## TECHNICAL MEMORANDUM

Date: August 5, 2011

Subject: N. Bizzell Street Proposed Pedestrian Improvements Evaluation  
Texas A&M University, College Station, Texas

EXHIBIT 1  
 PEDESTRIAN IMPROVEMENTS  
 N. BIZZELL STREET

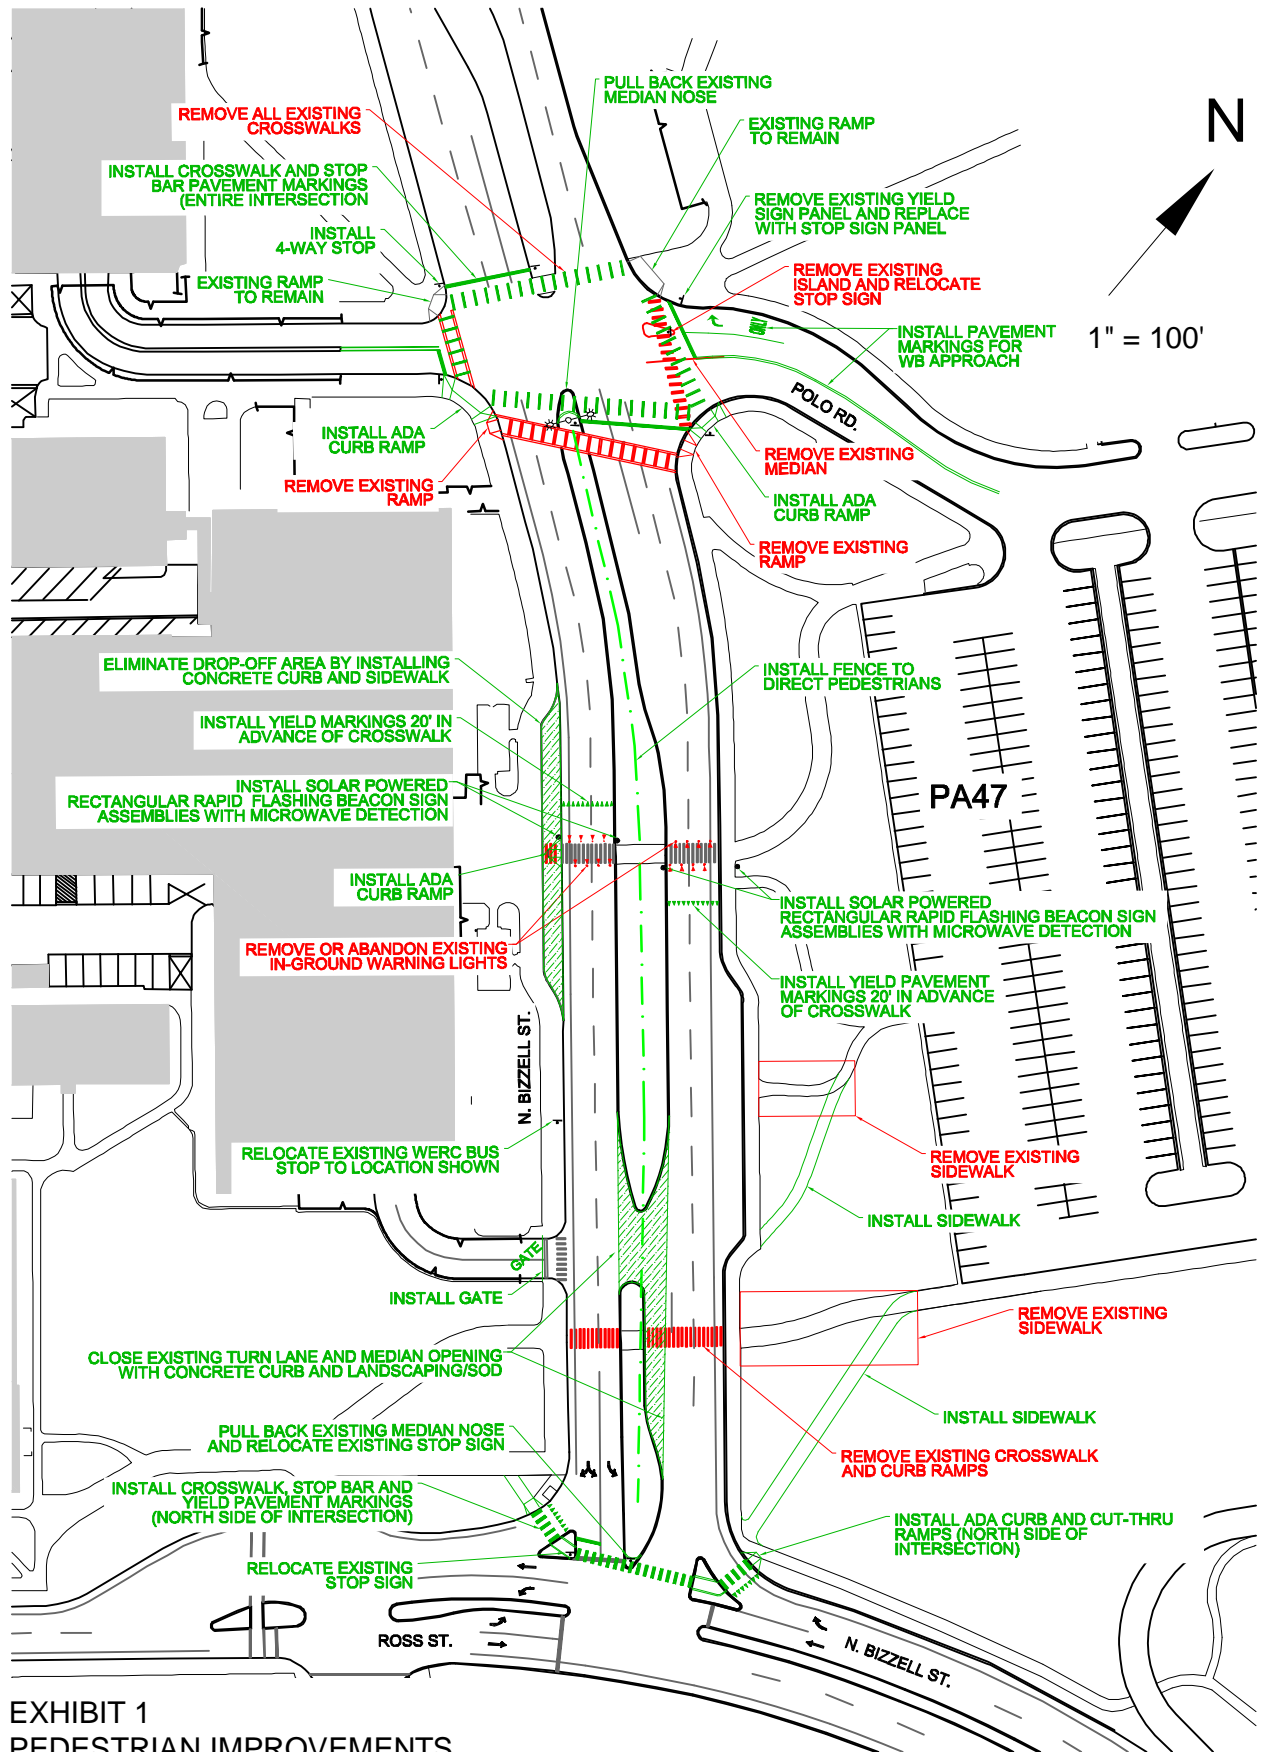
Per your request, we have reviewed the pedestrian accommodation along N. Bizzell Street from just north of Polo Road to Ross Street. Based on our review we offer the following comments and recommendations (see also the attached **Exhibit 1**):

5. The middle and southernmost sidewalks coming from parking area 47 (PA 47) should be reoriented to N. Bizzell Street as shown on **Exhibit 1**.
6. The existing northbound left-turn lane and median opening just north of Ross Street should be removed and replaced with a raised curb and landscaping/sod.

EXHIBIT 4  
AUTOTURN SIMULATION (40' BUS) WITH EXISTING CURB RETURN RADIUS  
N. BIZZELL STREET AT POLO ROAD

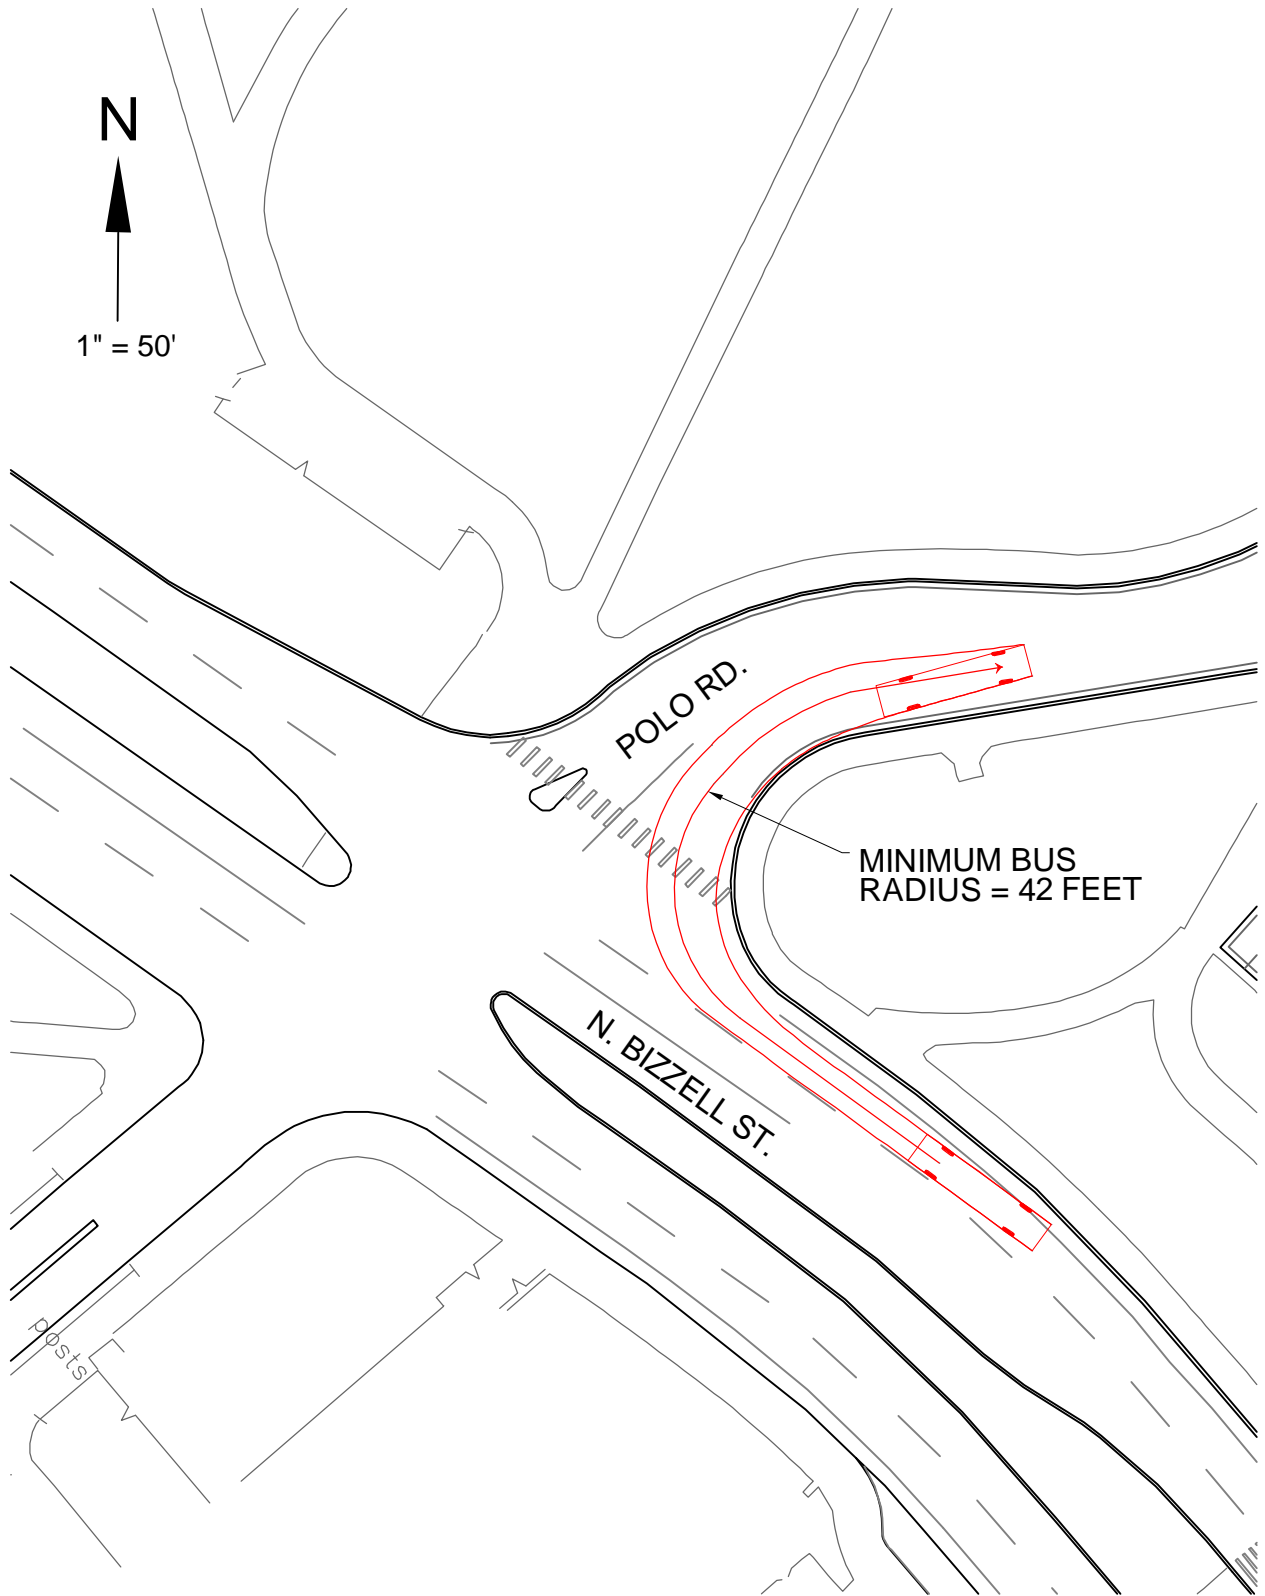
2. The existing curb return radius for the southeast corner of N. Bizzell Street and Polo Road should remain in place. The existing radius is needed to accommodate a large design vehicle (e.g., campus bus, RV, Single-Unit truck, etc.). **Exhibits 4 and 5** illustrate the minimum bus turning path based on the existing radius and a shorter radius. Any shorter radius would require a vehicle to either jump the curb or encroach onto oncoming traffic along Polo Road.
